PREPARED BY / DATE \_\_\_\_\_ CHECKED BY \_\_\_\_\_  
RESIDING STRESSES IN UNDERGROUND PIPING DUE DATE \_\_\_\_\_

SUBJECT \_\_\_\_\_ REV / DATE \_\_\_\_\_  
DIFFERENTIAL SOIL SETTLEMENT - MIDLAND PLANT UNIT # 152

THE PROFILES OF SEVERAL OF THE LINES OF FIGURES 17.2 AND 19.1 OF REF. 1 WERE ANALYSED BY AN ETEC IN HOUSE COMPUTER PROGRAM IN AN ATTEMPT TO VERIFY THE MAXIMUM STRESSES FOR THESE LINES PER REF. 1. THE MAXIMUM STRESSES OBTAINED FROM THIS ANALYSIS WERE CONSIDERABLY HIGHER THAN THOSE OF REF. 1. HAND CALCULATIONS WERE ALSO MADE AS AN ADDITIONAL CHECK WITH THE RESULTS BEING SIMILAR TO THOSE OF THE COMPUTER ANALYSIS.

FIG 19.1 Ref 1

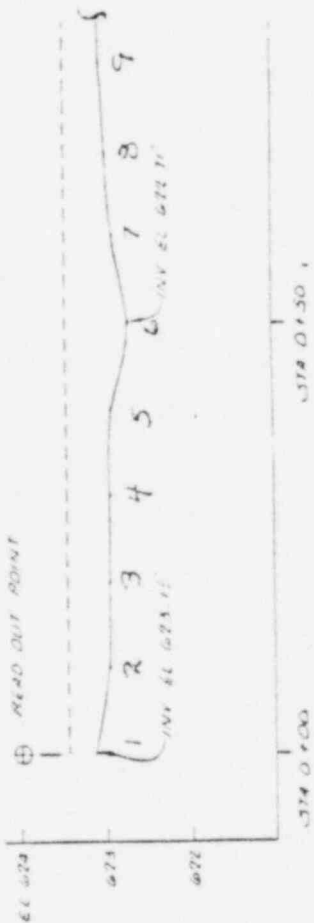
<u>LINE NO.</u>	<u>FIG</u>	<u>CASE</u>	<u>NODE</u>	<u>STRESS</u>
26"-04BC-54	19.1	1	6	212200 PSI
"	19.1	2	6	216200 PSI
26"-04BC-55	17.2	1	25	179200 PSI
"	17.2	2	2	46000 PSI
8"-14BC-81	19.1	1	20	84700 PSI
"	19.1	2	20	85200 PSI
20" 14CD-169	17.2	1	54	191800 PSI
"	17.2	2	54	192700 PSI

SIMPLE HAND CALCULATIONS WERE MADE TO VERIFY THE COMPUTER ANALYSIS FOR THE SECTION OF LINE 26" UN3C-5T IN THE AREA OF THE DIP BETWEEN NODES 5 AND 7

1) THE SECTION OF THE LINE BETWEEN NODES 5 & 7 WAS ASSUMED TO BE A SIMPLY SUPPORTED UNIFORMLY LOADED BEAM WITH THE MAXIMUM DEFLECTION AT NODE 6

5) THE METHOD GIVEN IN RESPONSE TO QUESTION 19 OF REF 1 IS AT BEST A ROUGH APPROXIMATION, BUT EVEN THIS METHOD GIVES VERY HIGH BENDING STRESSES FOR THE AREA BETWEEN NODES 5 & 7

THE HAND CALCULATIONS OF THE BENDING STRESSES (CASES 1-47) CONFIRM THE COMPUTER OUTPUT STRESSES IN GENERAL. IF THE END FIXITY AT JOINTS 5 & 7 WERE FACTORED IN THERE WOULD BE BETTER AGREEMENT

IN ALL CASES THE STRESSES WERE WELL ABOVE THE YIELD STRENGTH OF THE MATERIAL AND ALSO THE CODE ALLOWABLES.
